STATE OF MAINE
DEPARTMENT OF TRANSPORTATION
☐ Approved
☐ Returned for Corrections
AUG 2[illegible] 1997
☒ Approved as noted
☐ Rejected

PROJ. NO. : BH-043-1(34)
ITEM NO. : 520.22

PROJECT: JOSHUA CHAMBERLAIN BRIDGE OVER THE PENOBSCOT RIVER, BANGOR-BREWER, ME

EXPANSION JOINT DETAIL @ PIER 1

PROJECT: JOSHUA CHAMBERLAIN BRIDGE OVER THE PENOBSCOT RIVER, BANGOR-BREWER, ME		
SCALE: ~	APPROVED BY:	DRAWN BY: BB
DATE: 7/97		CHKD. BY:
SIDEWALK DAM DETAIL @ HINGE SPAN 7		
REED & REED	JOB NO. 97-49	DWG. NO. 15

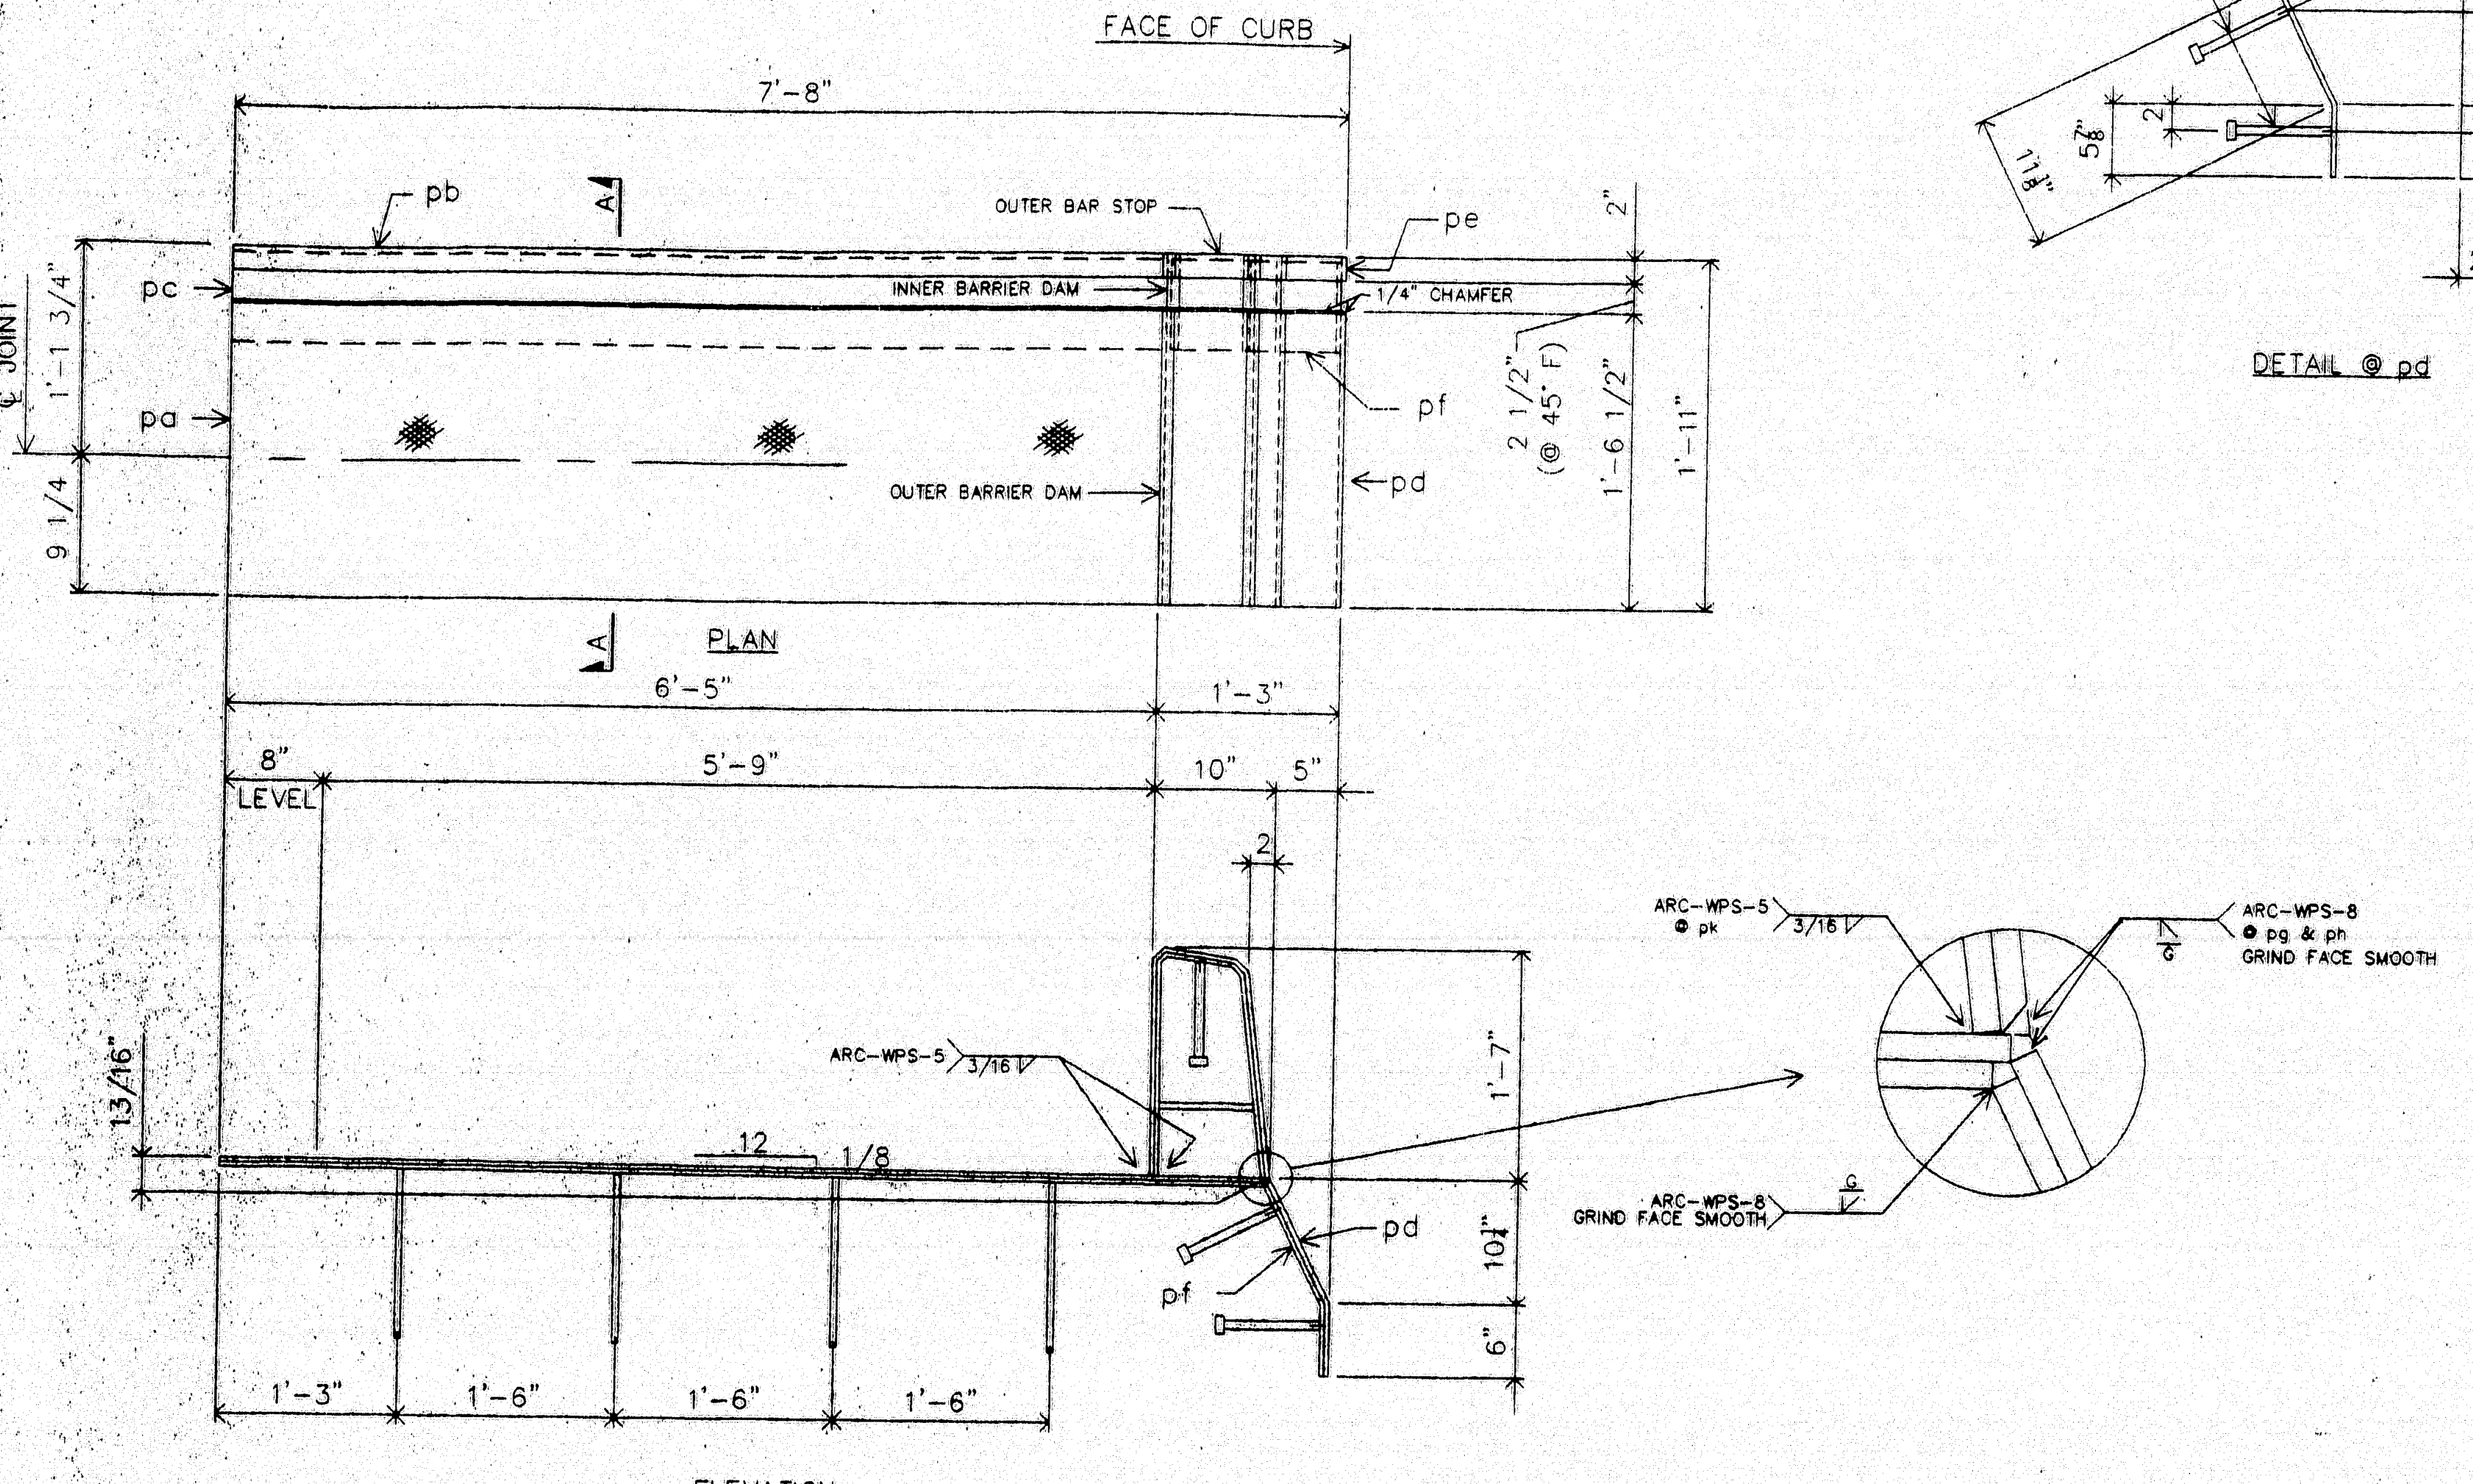
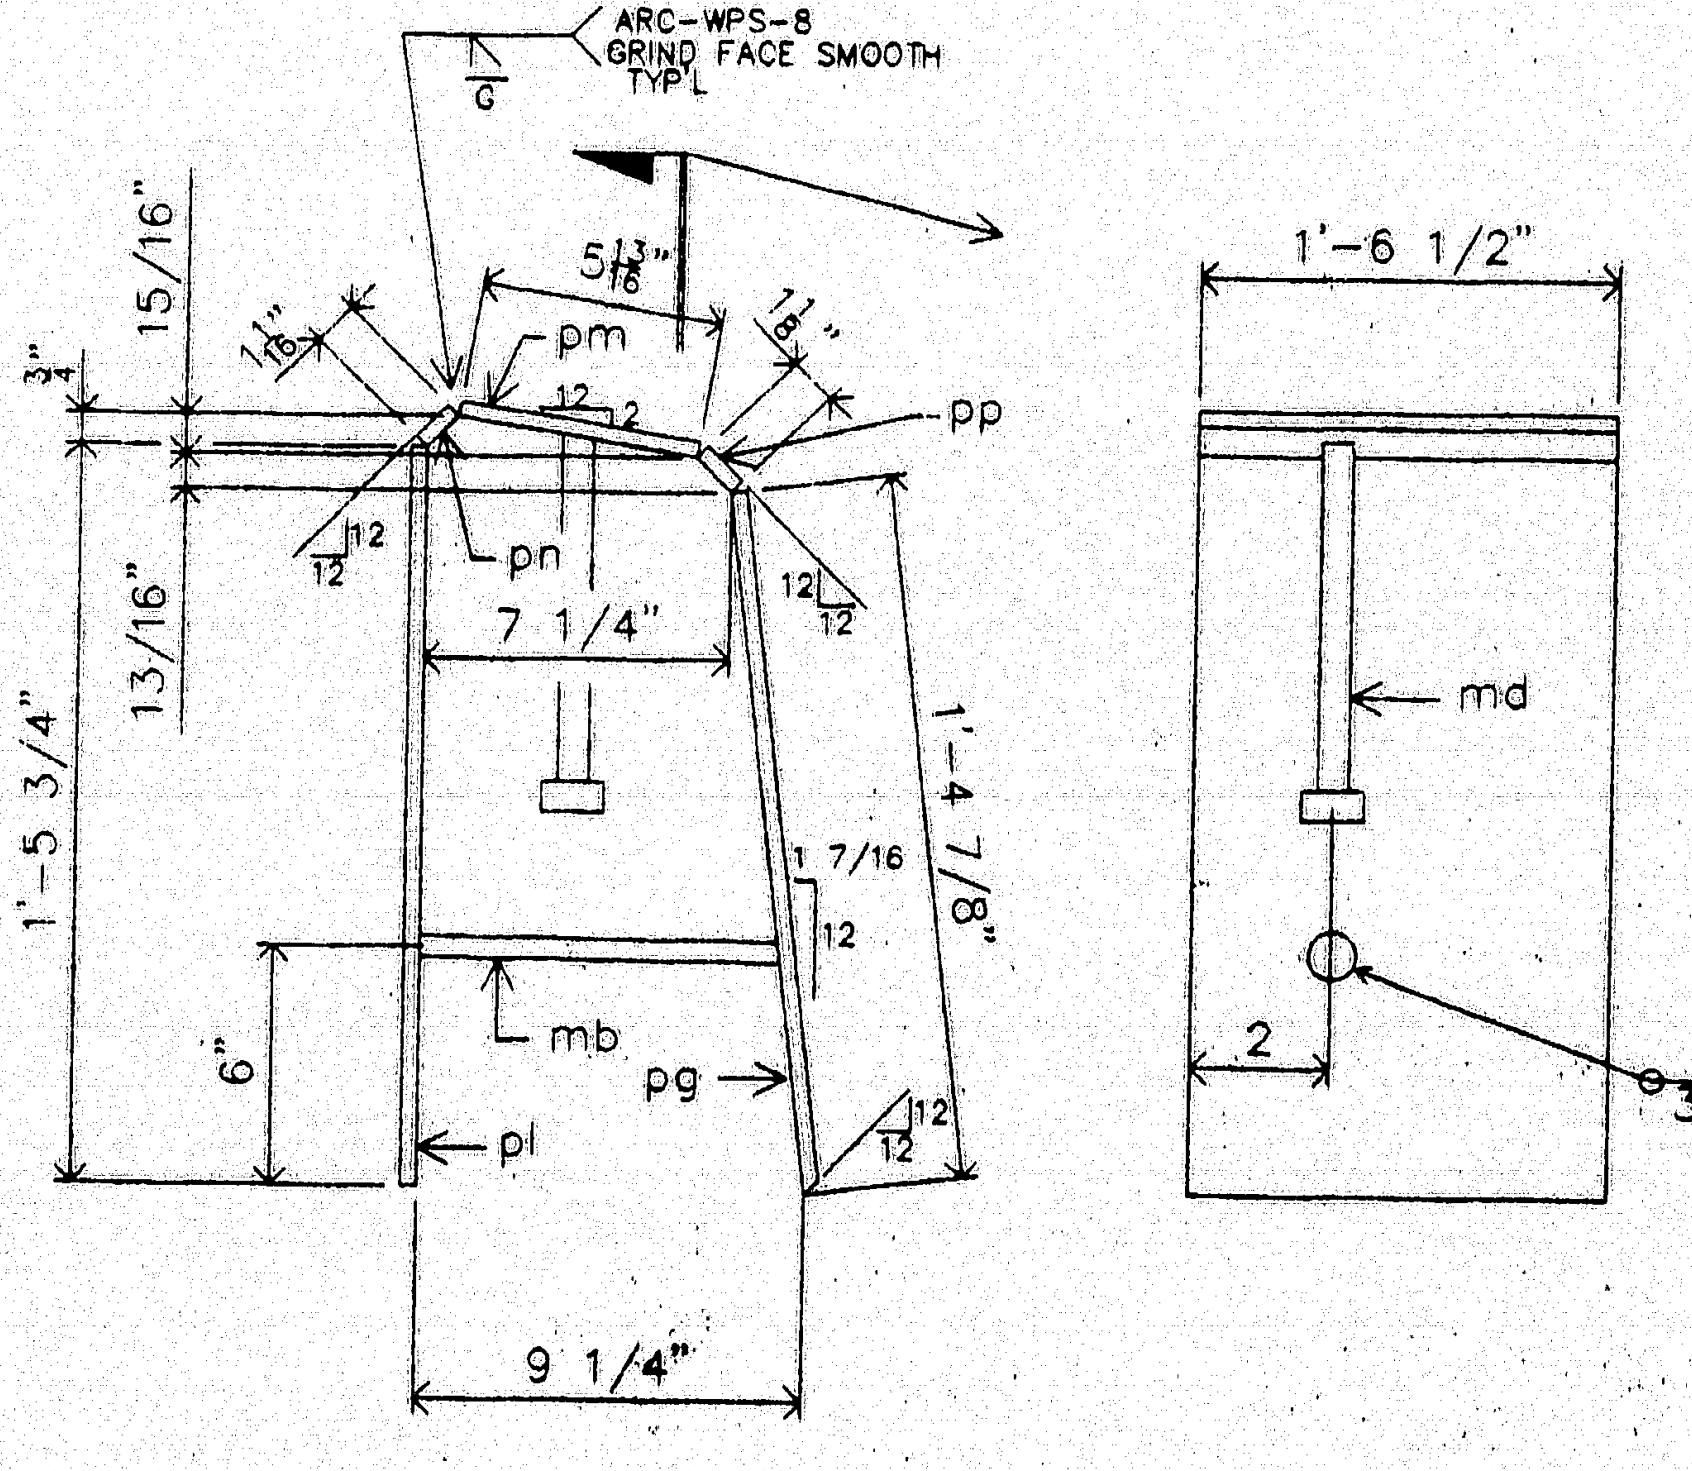
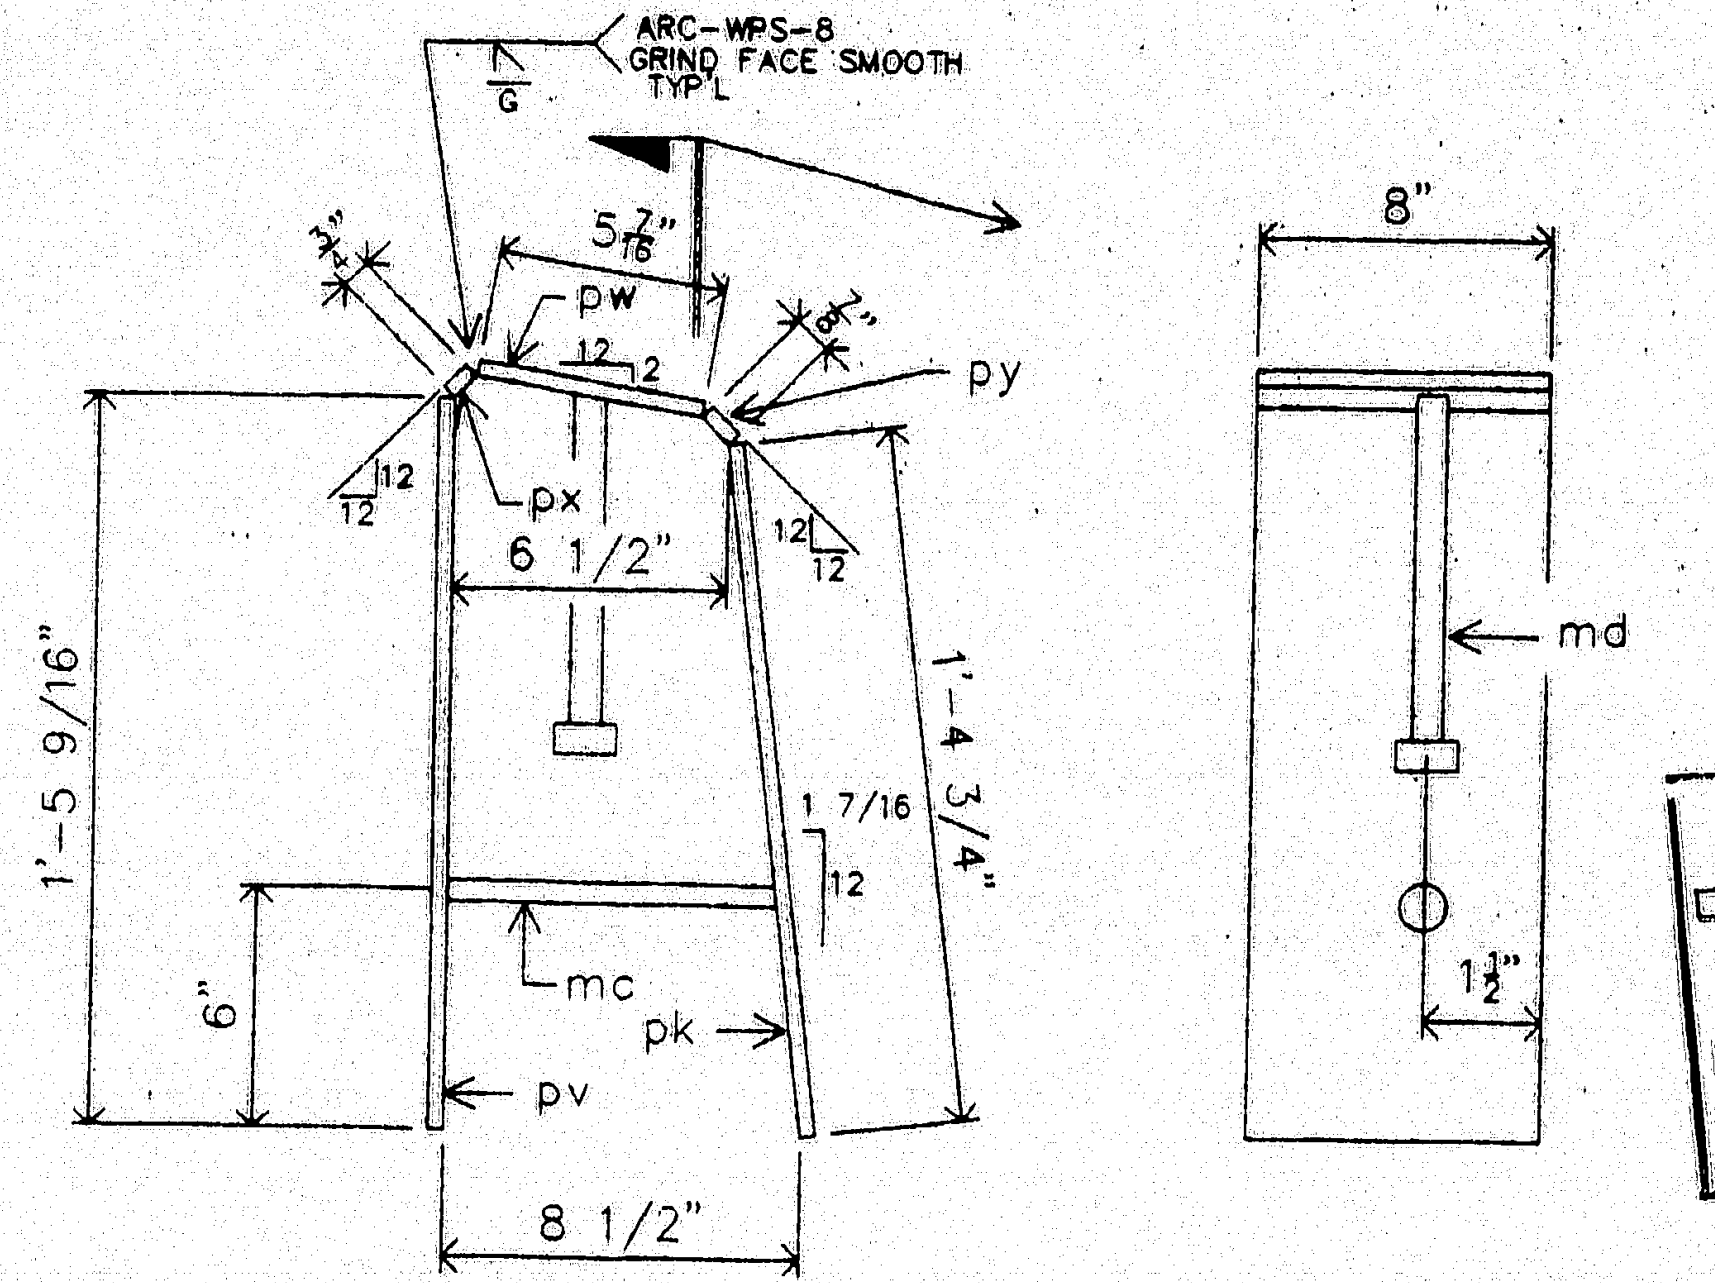
X-tra Work

MATL: A36 UN HOLES: AS NOTED
WELD: PER PROCEDURES NOTED
PREP: SP6
FINISH: ~~3 COATS ZINC RICH PRIMER~~
~~3 MDFT PER COAT~~

Prefered Option: Get Price for Galvanizing Assembly.

(or)

Select Paint System from Nepcoat List.

Typical Systems

1. Inorganic Zinc Primer.
2. 2 Part Epoxy.
3. Urethane Topcoat.

Carboline
Wasser
Keeler & Long
Valspar
